Question 16: the Great Hall's doors open through 3 m of wall

The Architect, 14 October 2026, for Godric. Ledger line 14, found drawing batch 3; the castle model, version 19. Plans and sections at 1:150, the cut on the doors' line looking north. Red: what changes.

1 The 3 m stays: a vaulted passage

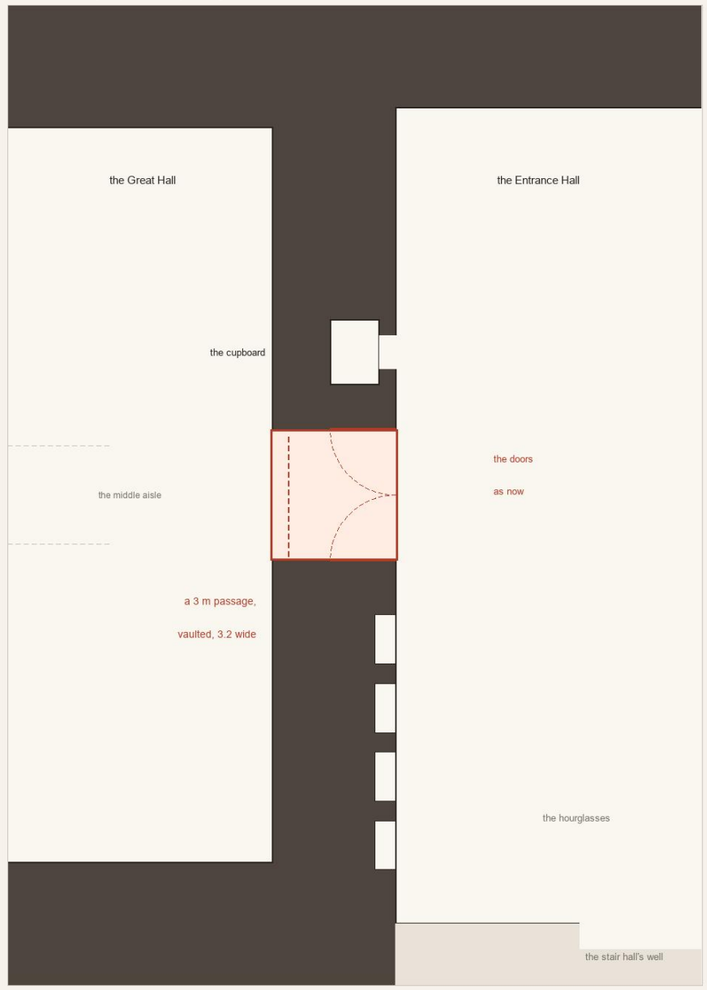
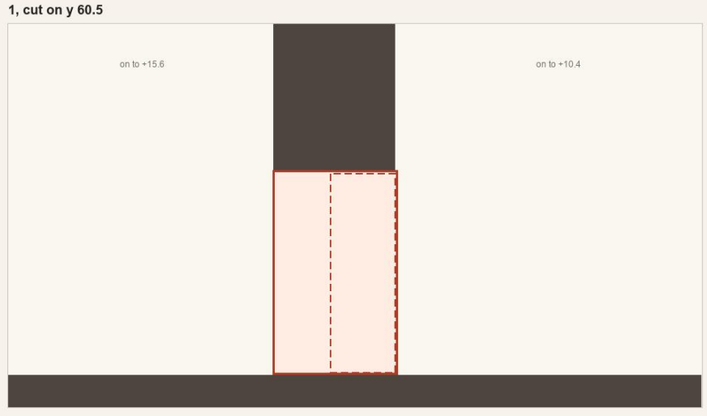
1, recommended. The 3 m stays and the doors open into a passage through it, 3.2 wide and vaulted, the leaves where they hang now in the Entrance Hall's face, swinging in. Your 14.1 cupboard and the hourglass niches stay; the hall stays 50 m, so Interiors' tables, the doors' stand at x 62 and the lane of sky down the aisle stay as placed. A castle's walls run this thick (a keep's, 3 to 6 m); you pass under 3 m of stone before the hall opens, and its sky opens with it.

2 The hall's wall moved to 66.8

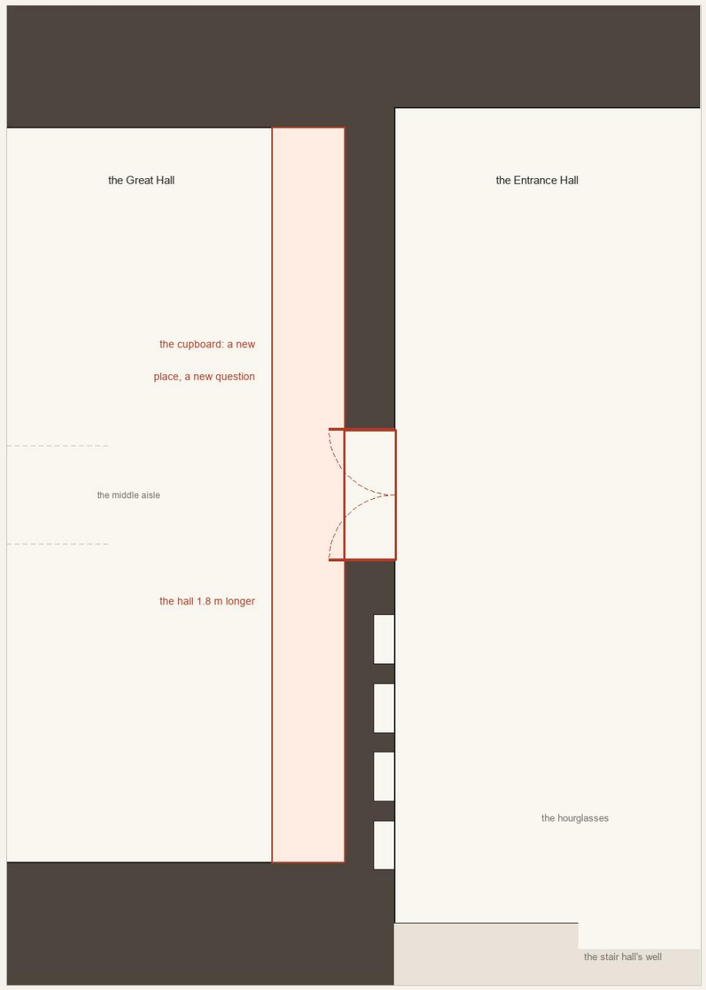
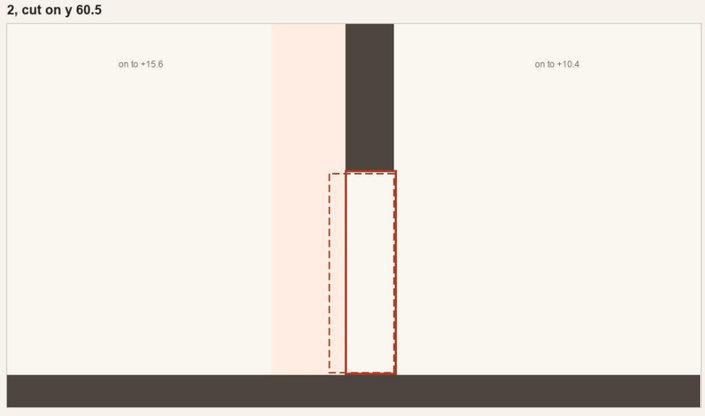
2. The hall's east wall moves to 66.8, a 1.2 m wall (the niches need 0.5 of it), the hall 1.8 m longer. The cupboard loses its place and needs a new one (a new question), and Interiors' tables and the doors' stand move with the wall.
